Title: Inspection of Rotor head		
AG-SB-2022-09-B-EN	Effective Date: 07.10.2022	Compliance Category: A - MANDATORY B - RECOMMENDED C - OPTIONAL
Applicability		
Aircraft type & model: All Cavalon and Calidus with Rotor head III	Affected Serial number(s): All Cavalon and Calidus with Rotor head III	
The maintenance manual to be referenced is this stated or subsequent issue.		As per AutoGyro website
This form is the response from AutoGyro GmbH either against a problem found in the product in service requiring a containment or rectification action, or as service information for aircraft modification incorporation. For help, contact airworthiness@auto-gyro.com .

Reason and overview of the Service Bulletin (cause of problem if known)

The purpose of this SB is to highlight the need for effective pre-flight and service inspection of the weld that joins the rotor head side plate to the roll link bracket.

Rotorhead III

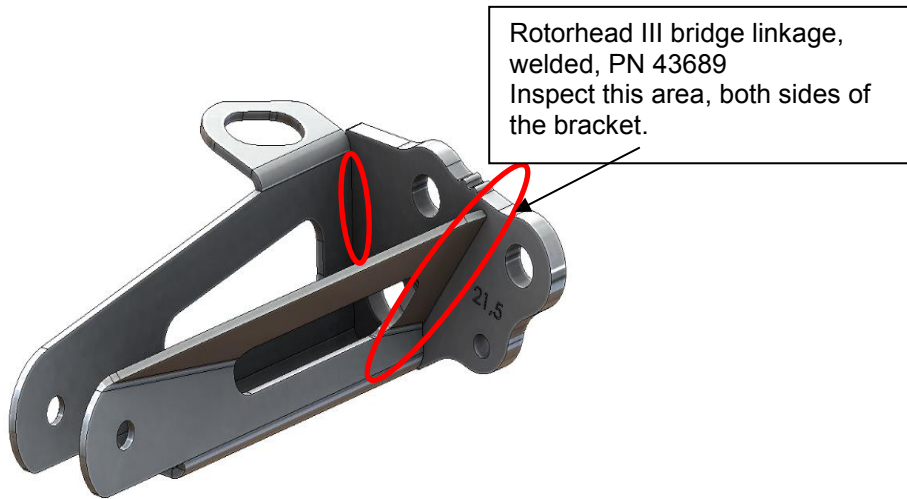
Pre-flight inspection requires a thorough review of the rotorhead. Pilot/operators are reminded that this includes the welded connection between the side plates and roll link bracket shown below. This area is open for easy inspection.

The ringed area indicates the installed bridge linkage

If a crack is found, the part is to be replaced in accordance with normal maintenance procedures.

External weld with crack:

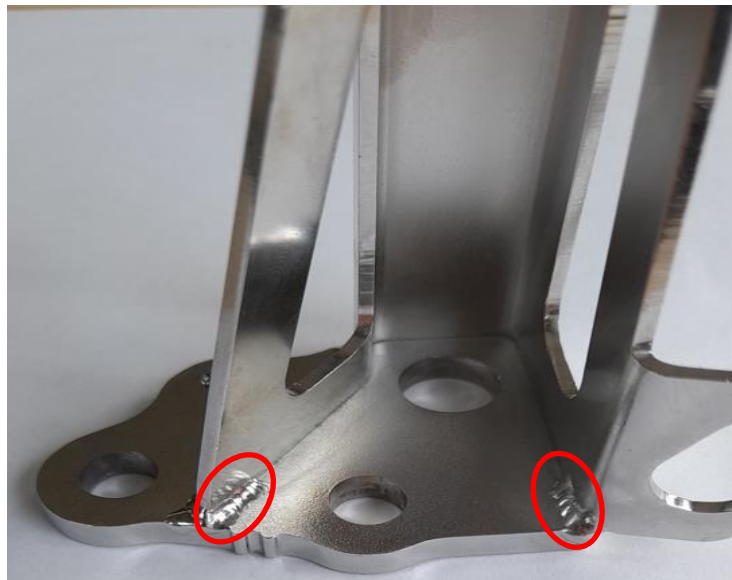
Reason; a small number of 1st generation Rotorhead III Rotor head bridge roll linkage assemblies were found during service inspection to have a weld crack. The inspection in this area is considered to be part of the pre-flight inspection, and the area is easily visually inspectable.

This area is readily inspected during pre-flight inspection

Note: these assemblies are stamped with the size (21.5 and 22.5). If replacing, ensure that the correct size is fitted!
